STAFF RECOMMENDATION
1104 Fatherland Street
September 21, 2016

Application: New construction - addition
District: Lockeland Springs-East End Neighborhood Conservation Zoning Overlay
Council District: 06
Map and Parcel Number: 08313009700
Applicant: John Root, rootARCH
Project Lead: Melissa Sajid, melissa.sajid@nashville.gov

Description of Project: Application is to construct a rear addition. No changes are proposed to the existing historic structure.

THESE DRAWINGS SHALL NOT BE REPRODUCED OR REUSED WITHOUT THE EXPRESS WRITTEN PERMISSION OF THE ARCHITECT. ALL DESIGNS AND INTELLECTUAL PROPERTY SHALL REMAIN EXCLUSIVELY OWNED BY THE ARCHITECT.

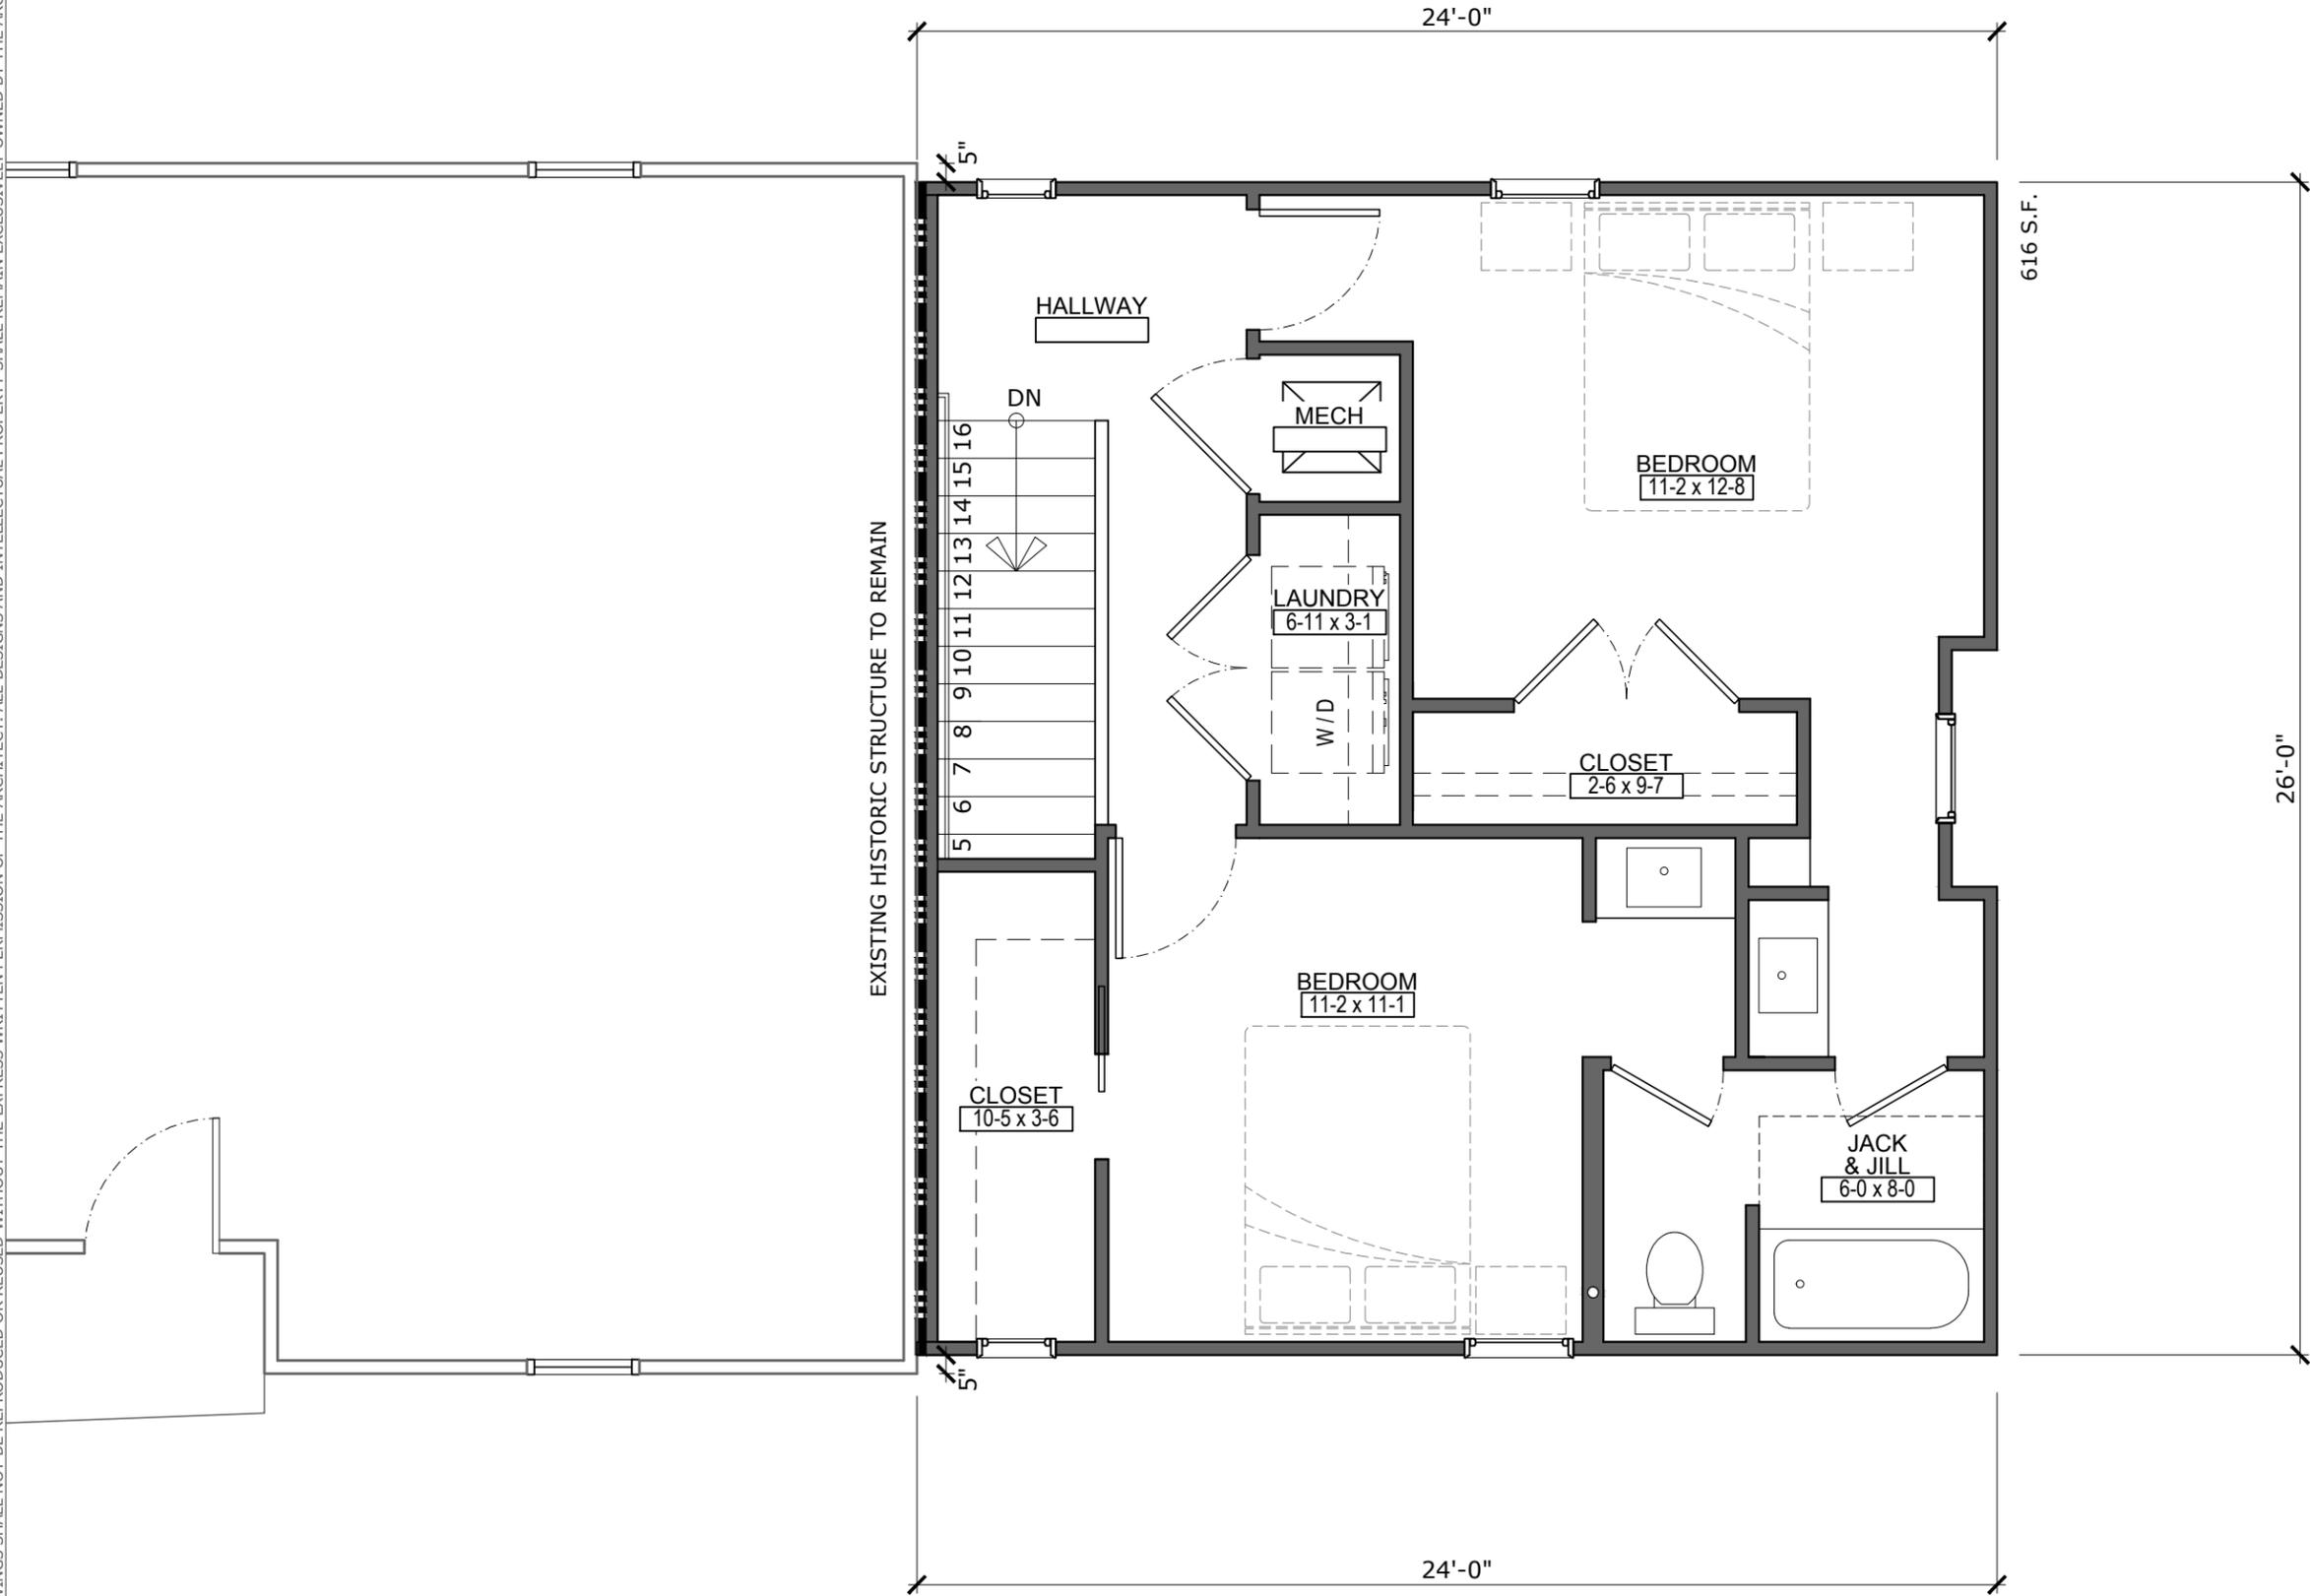
Design, Location & Removability: The new construction is located at the rear of the historic house, in accordance with design guidelines. However, the addition does not meet the design guideline that requires the new construction to be inset one foot (1') per story from the rear corners of the historic house. As proposed, the addition sets in three feet, four inches (3'-4") from the right corner and five inches (5") from the left on the basement and first floor levels and five inches (5") from each corner on the second floor level. The applicant contends that the proposed insets are sufficient since the rear corners are obscured by existing bump outs located closer to the front of the historic structure. The 1914 Sanborn map, however, shows that the existing rear corners are likely original to the structure (See Figure 2). Setting in the addition one foot (1') per story helps to ensure that the new construction is distinguished from the existing historic structure, allows the full form of the original building to be kept intact and would allow for original conditions to be restored, if desired in the future. As proposed, the addition does not meet this requirement.

Staff finds that the rear addition is inappropriate as it does not meet the design guidelines for removability. The project does not meet Sections II.B.10.a.

SOUTH ELEVATION

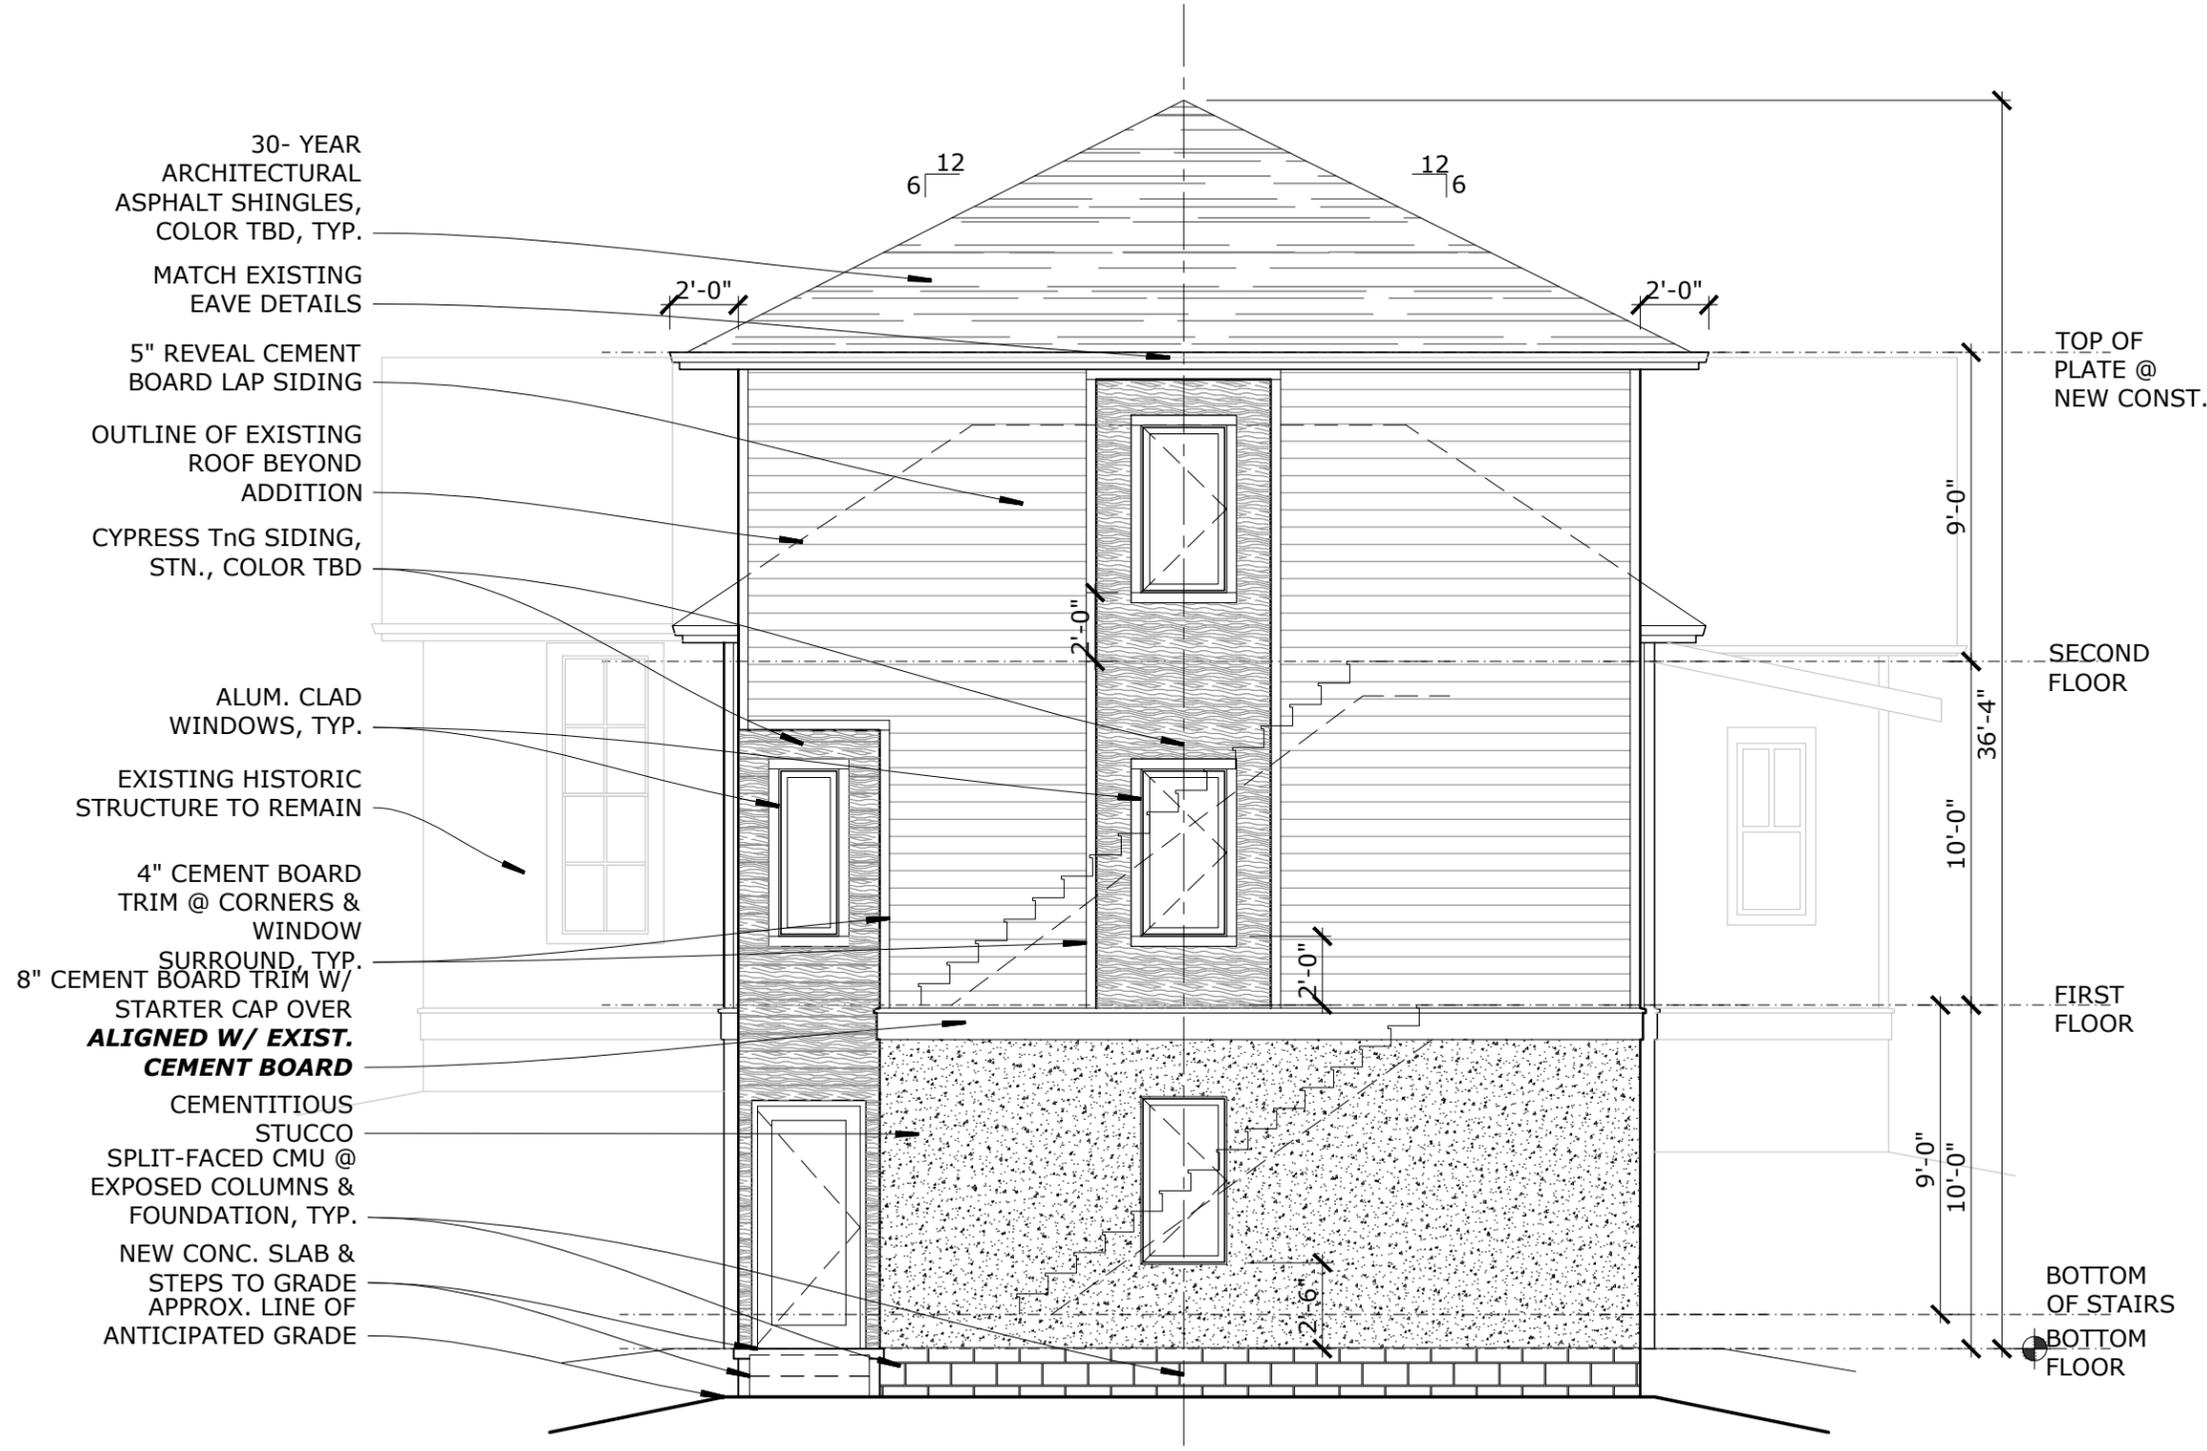
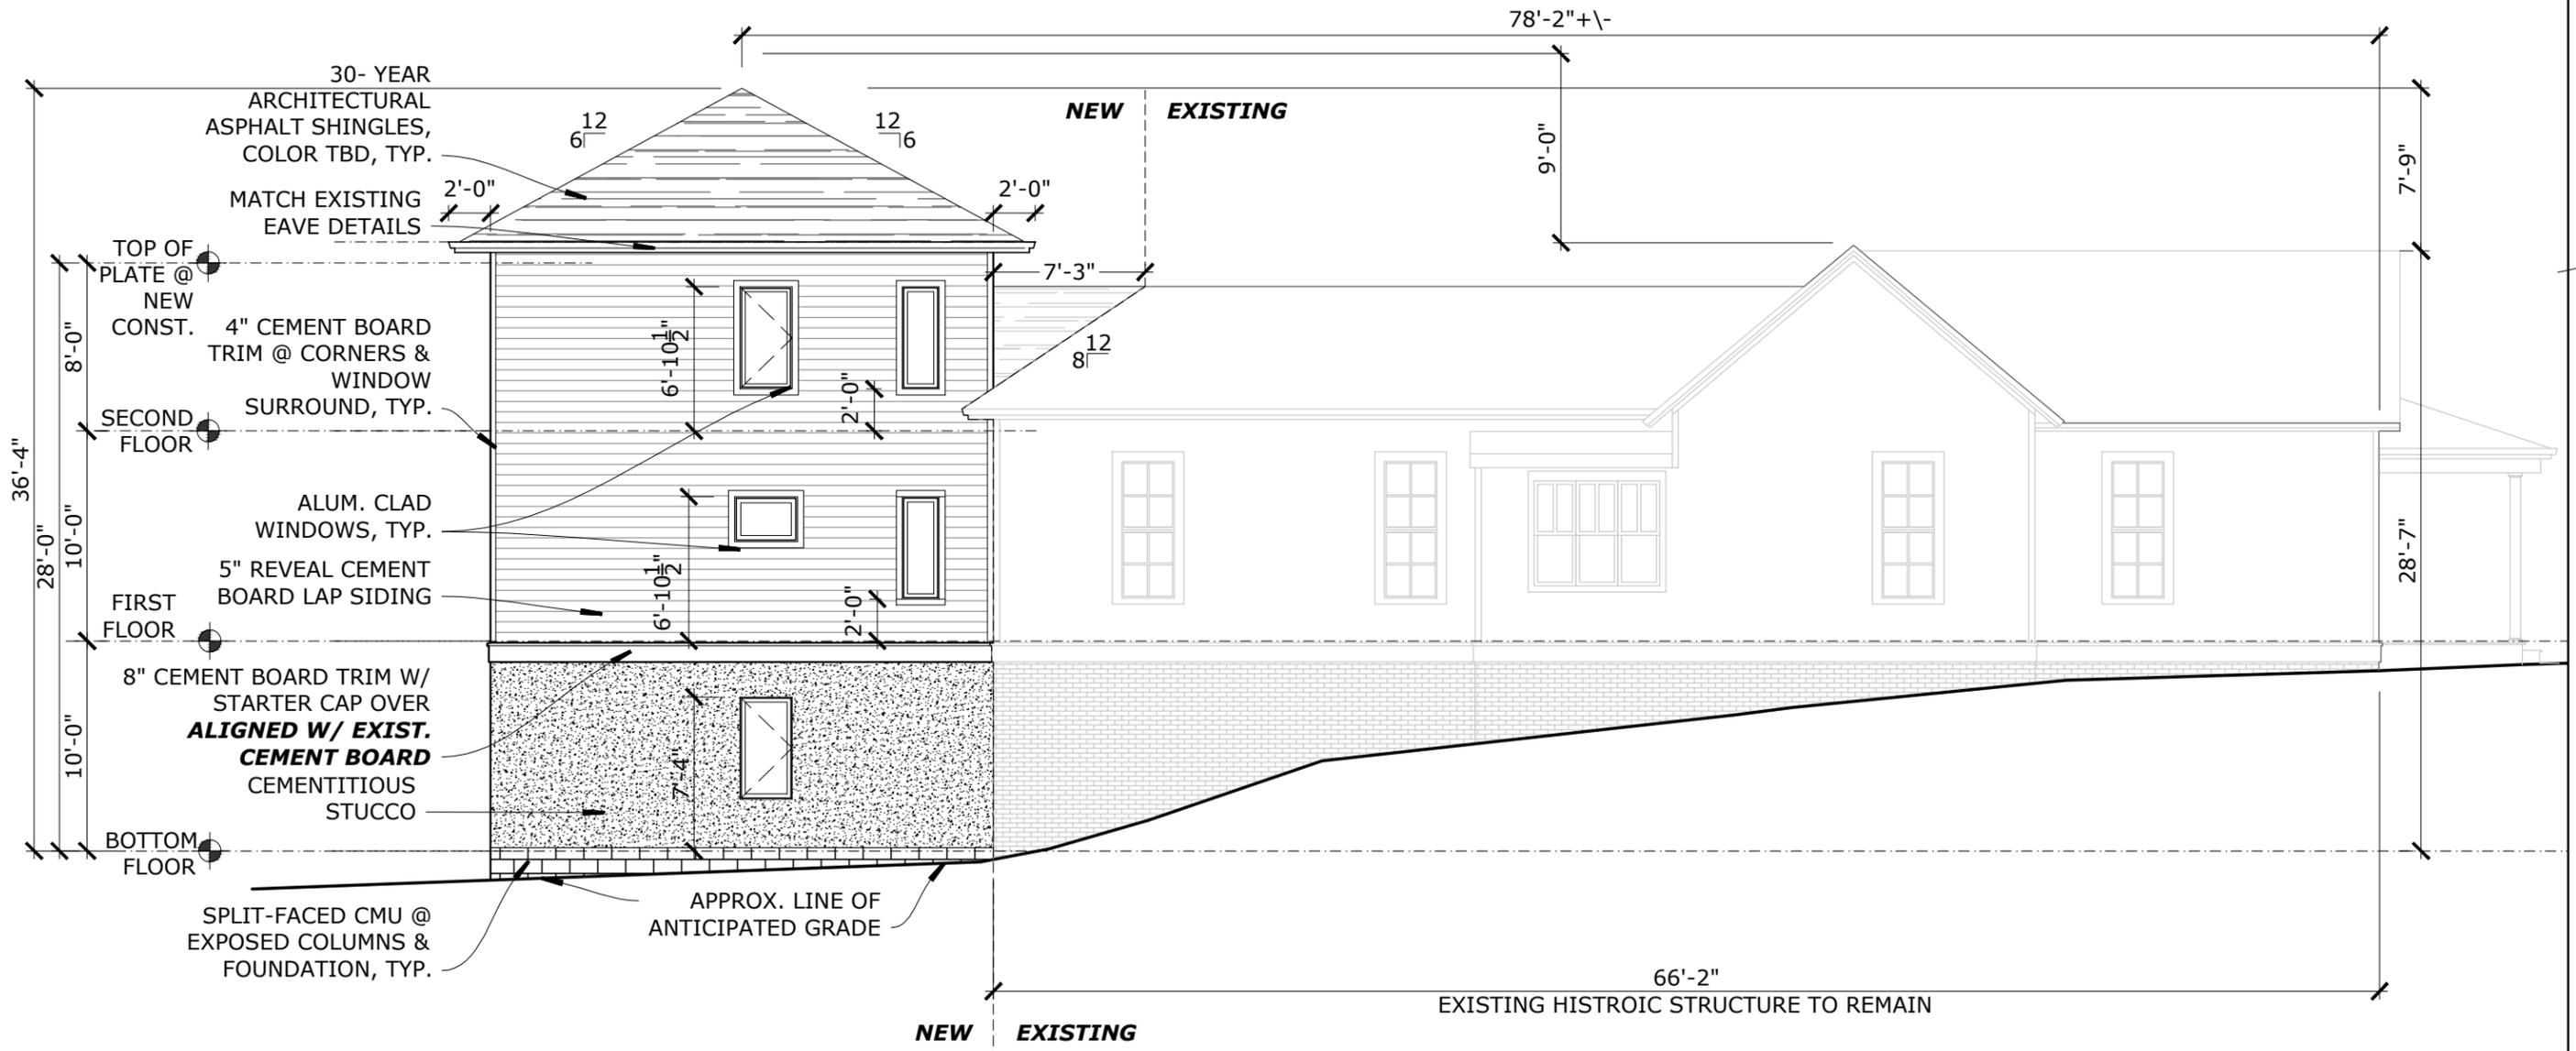
As proposed, the addition is significantly taller than the historic structure. The design guidelines require that ridge and eave heights of an addition be the same-as, or lower than, the existing building in order to meet the requirement that addition be “compatible in scale” to the historic building and “kept to a minimum.” The italicized portion of the design guidelines also allows additions to be up to four feet (4') taller than a historic structure when the additional height is located at least forty feet (40') from the front edge of the existing building and “when a taller addition is the only option.” In this case, the grade drops significantly front the front of the lot to the rear, allowing the possibility of a basement level, or two-story addition behind this one-story house. Staff does not find that additional height is necessary, in this instance.

The proposed additional height begins approximately sixty-five feet (65') behind the front wall of the historic structure and is approximately seven feet, nine inches (7'-9") taller than the historic structure at its tallest point. However, the addition is nine feet, six inches (9'-6") taller than the historic structure at the front due to the change in grade on the site. The plan includes the basement and two additional stories, which altogether overwhelms the existing historic structure.

While the proposed rear addition does not more than double the footprint or depth of the house, staff finds that the rear addition is not compatible in scale to the historic building and is "visually jarring." Staff finds that the project does not meet Sections II.B.10.a and b.

Staff recommends disapproval of the proposed rear addition, finding that the application does not meet Section II.B of the design guidelines for the Lockeland Springs – East End Neighborhood Conservation Zoning Overlay. The proposed height and scale of the addition are incompatible with the existing single-story historic structure, and the addition is not easily removable, allowing for a full restoration if desired in the future.
